# Installation of New ALPS treated Water Dilution/ Discharge Facilities and the Related Facility

Tokyo Electric Power Company Holdings, Inc.

## **1. Responses to major issues\*1 concerning the content of the application for the Discharge facility of ALPS Treated Water into the Sea**

## **2. Responses to issues pointed out\*2 at the review meeting, etc.**

### 2. Plan for the circulation and agitation demonstration test

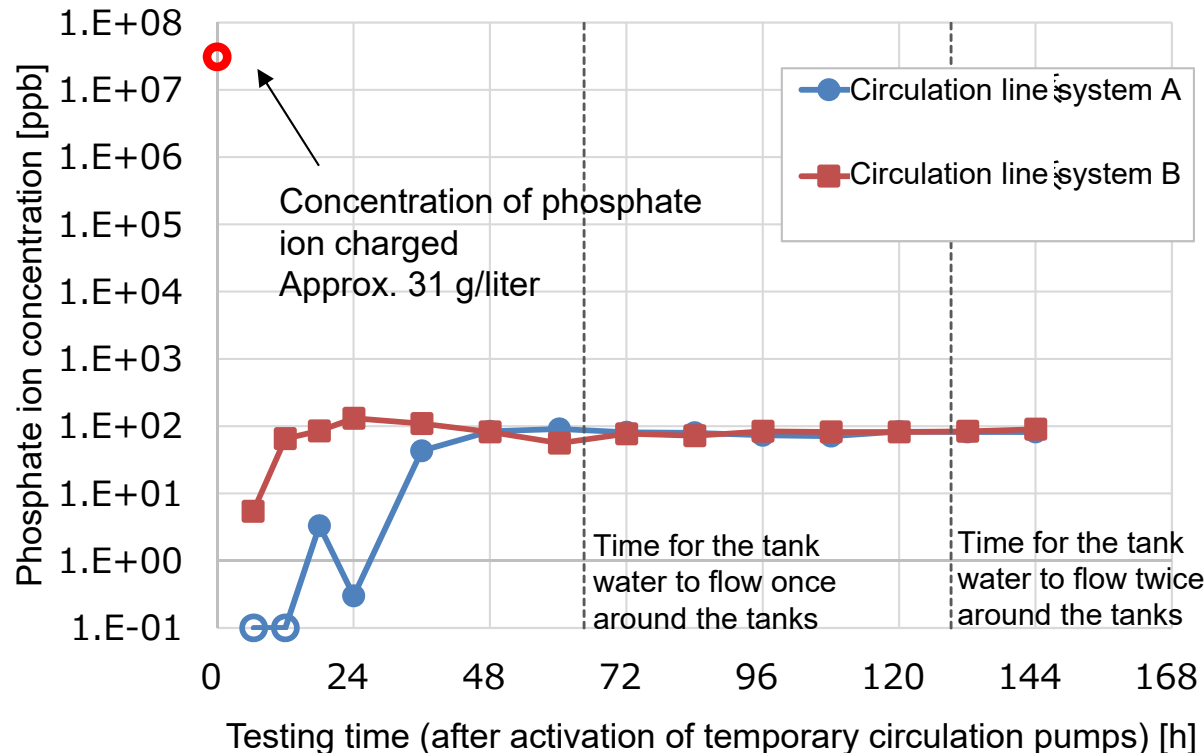
- Explanations must be provided regarding the method for homogenizing the radioactive concentration in ALPS treated water in the K4 area tanks before discharging into the sea and the validity of the method.

- In the circulation and agitation demonstration test, the effect of homogenizing phosphate and tritium concentrations will be confirmed according to the plan shown in the table below.

Date of testing	February 7, 2022 - February 13, 2022		
Testing time	Approx. 144 hours		
Tanks subject to the test	K4-Group B (10 units)		
Reagent*1	Tribasic sodium phosphate*2 (Charged through the manhole on the top plate of K4-B6 tank)		
Sampling	Before the test	During the test*3	After the test
Sampling point	Tanks from K4-B1 to B10 Middle (5 m)	2 points in the circulation line	Tanks from K4-B1 to B10 Upper (10 m)/Middle (5 m)/Lower (1 m)
Sampling volume	10 units of 1-liter samples	28 units of 1-liter samples*5	30 units of 6-liter samples
Subjects to be analyzed	Phosphate*4	Phosphate*5	Phosphate + 7 major nuclides*6 + tritium

### [2]-3. Emergency shutdown

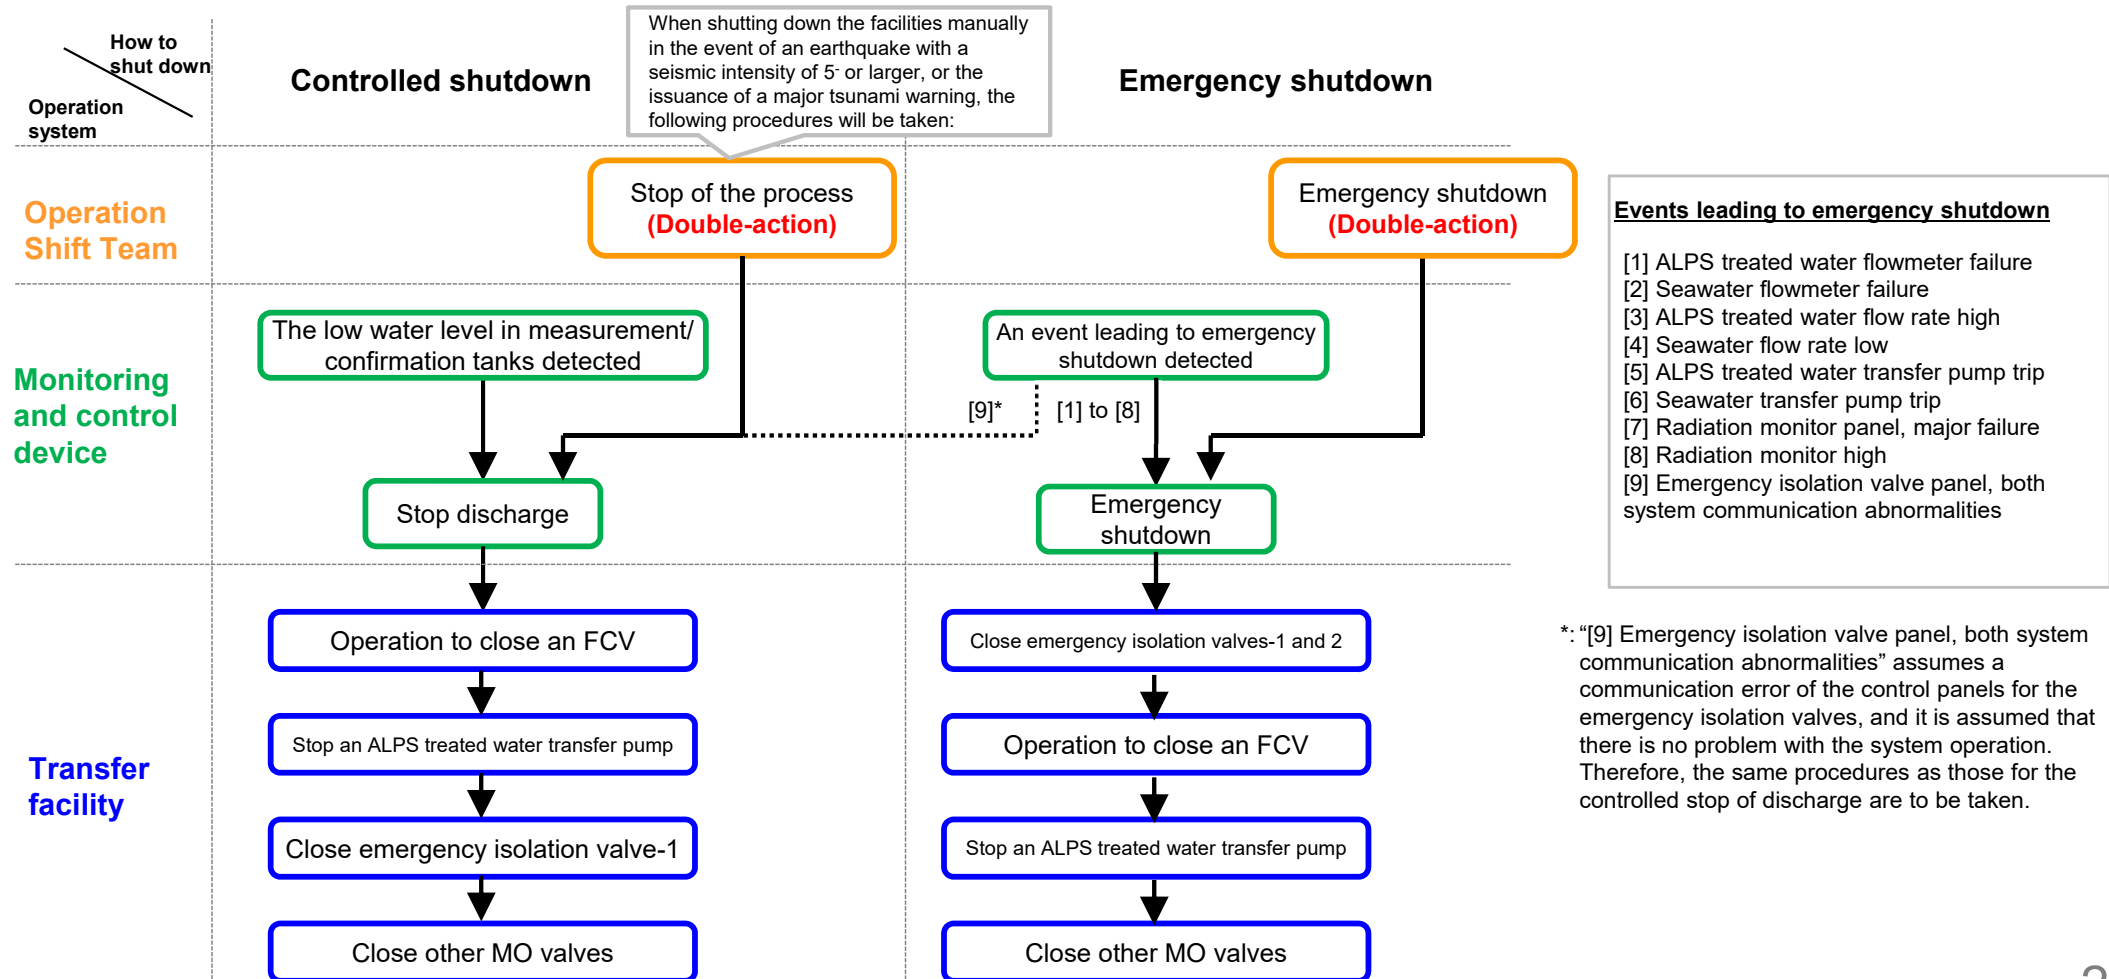
- An explanation must be provided about whether other facilities will be manipulated or not in the event of a malfunction of an emergency isolation valve during normal operation. As procedures for diactivation the discharge operation, the manipulation of emergency isolation valves is required in some cases, while it is not in others. The details of the stop procedures in both cases must be explained, and with regards to the former emergency isolation valves, their role and rationale for the number of units set must be clarified.

- During the discharge of the ALPS treated water, in addition to normal shutdown, the facilities may be shut down as an emergency measure when abnormalities, such as deviation from normal operation, are detected.
- In both normal and emergency shutdown cases, almost the same shutdown and operation commands will be input. (Only the manipulation of emergency isolation valve-2 is different. Emergency isolation valve-2 is to be operated only at the time of emergency shutdown or inspections).
- Except for manual shutdowns, all facility shutdowns are designed to be controlled by the monitoring and control device, which detects the status of the facilities.

### [3]-1. Points where misoperation can occur and concept for interlock

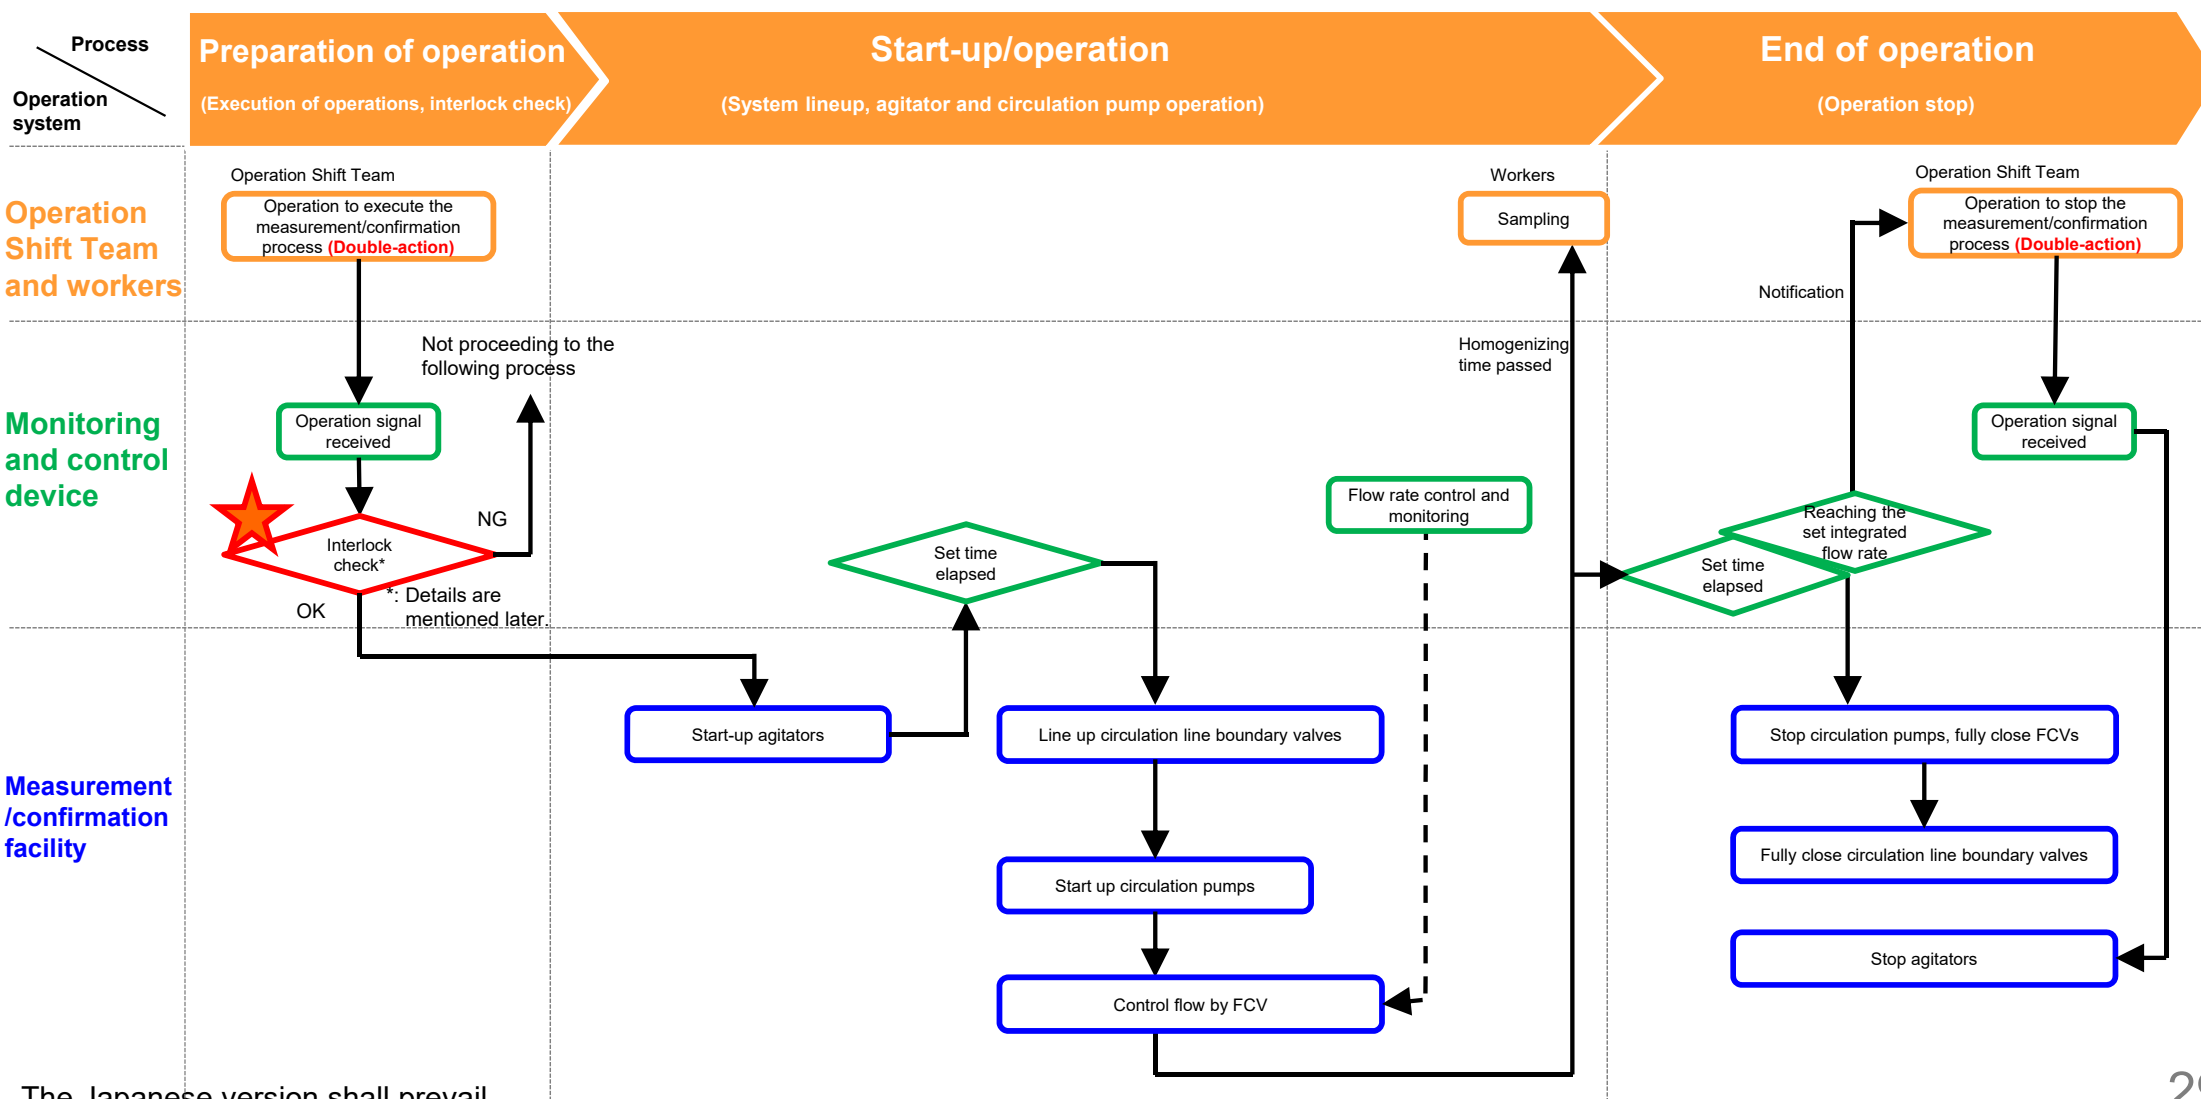
- Regarding the monitoring and control device, the frequency of registration operations and the areas requiring human intervention must be clearly indicated.  
It is also important to comprehensively consider where and what errors can occur. From the viewpoint of preventing human errors, it is sometimes considered that human intervention should be minimized. On the other hand, however, such an idea can cause the device to become a black box. Therefore, misoperation prevention measures that are appropriate from a comprehensive perspective must be clarified.

- The countermeasures to prevent misoperation by operators and other postulated misoperation occurring while the ALPS treated water Dilution/Discharge Facilities are in service are summarized as follows.

- In addition to the above measures, in order to further augment the function to prevent “unintentional discharge of ALPS treated water into the sea”, an interlock is provided to stop proceeding to the following process (including the operation of equipment), mainly even when an operation that cannot be undone is performed by mistake.
  - ✓ Release of radioactive materials from measurement/confirmation tanks due to lack of confirmation
    - Even when a wrong tank group is selected for measurement and confirmation by mistake, the operation of the equipment will be stopped.
  - ✓ Discharge of water with a tritium concentration of 1,500 Bq/L or more after dilution with seawater
    - If the tritium concentration is not below the discharge limit or the dilution ratio is not acceptable, the system cannot proceed to the following process (discharge operation).

**[4]-2. Verification points in the analysis procedures**

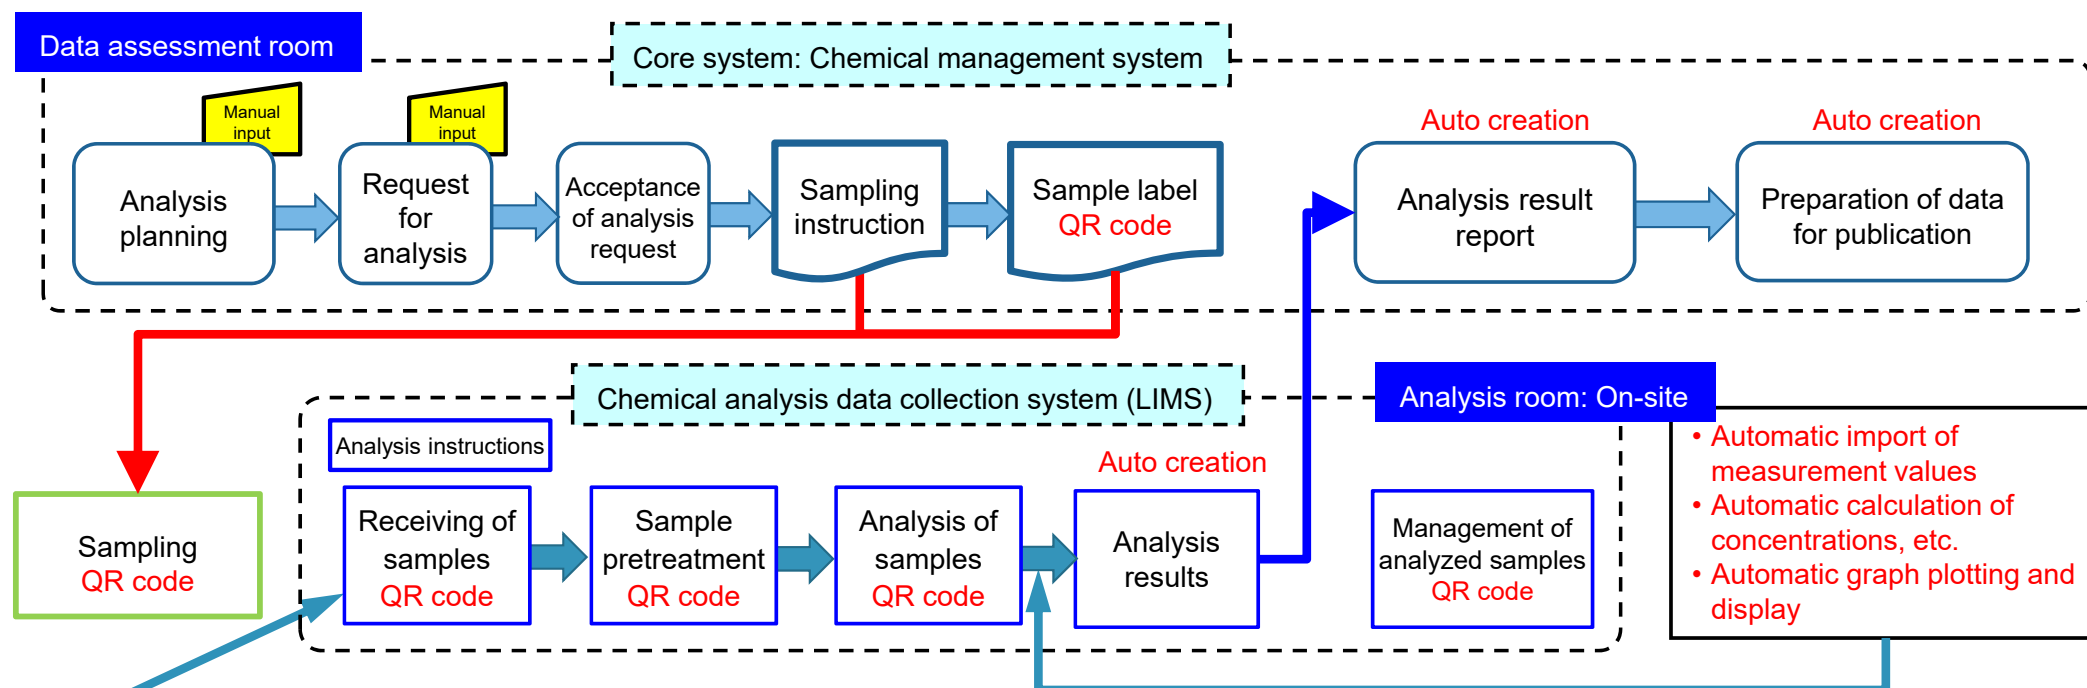
- According to the analysis procedures, most processes are implemented within the core system to prevent human errors. An explanation must be made about what measures and mechanisms are established to enable operators to ensure that the system is appropriately carrying out analyses.

■ Verification points in the analysis procedures are as follows:
